**FINDINGS OF FACT
FLORENCE COMMUNITY DEVELOPMENT DEPARTMENT
Planning Commission
Exhibit "A"**

Public Hearing Date: October 25, 2016 **Planner:** Glen Southerland
Date of Report: October 18, 2016
Application: PC 16 22 CUP 06

Proposal: A request for a conditional use permit to approve the construction of a Public Works facility with a 5,942 square foot office building and a 7,754 square foot maintenance building on Lots 12, 13, and 14 of the Pacific View Business Park.

C2.1

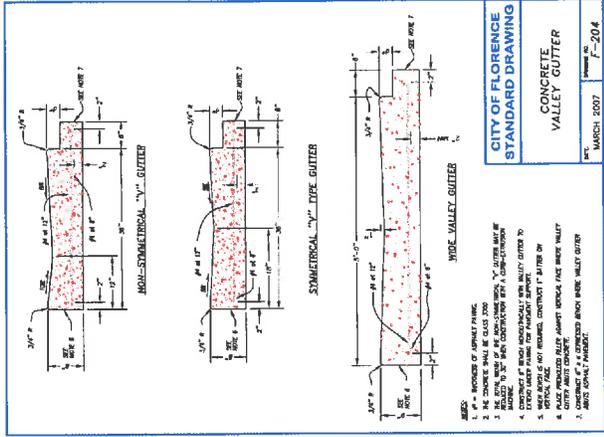
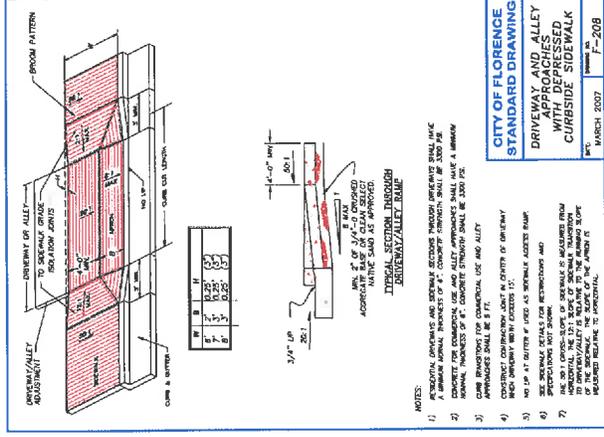
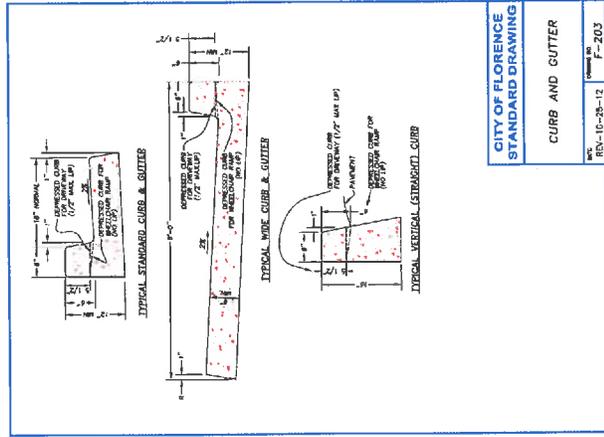
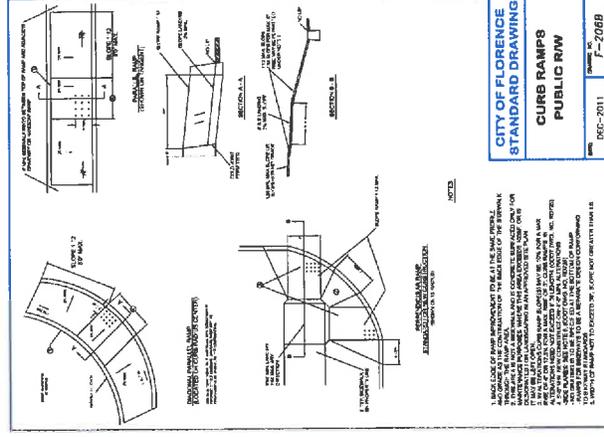
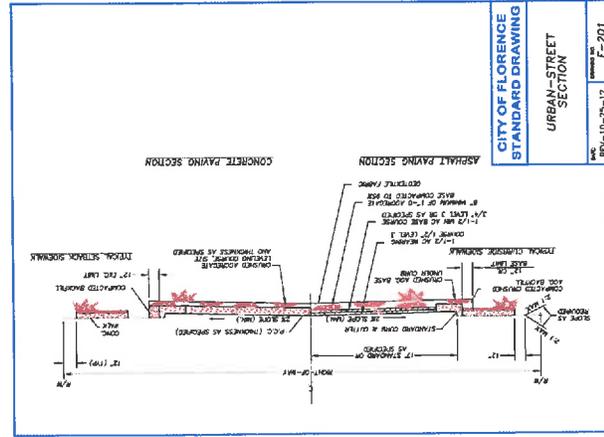
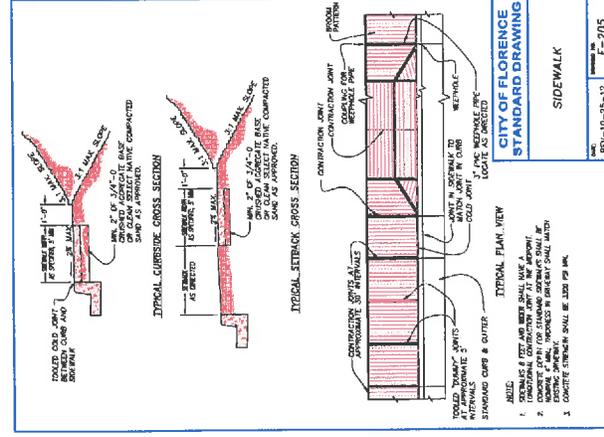
Sheet C2.1 cites Standard Drawing F-205 for sidewalk construction between the parking lot and landscaped areas adjacent the building. This standard drawing does not state the height of the curb, however, wheel stops are also called out as Note #13 and shown on Sheet C2.2. The parking area is also physically separated from the building by a landscape buffer of greater than five feet in width. This criterion is met.
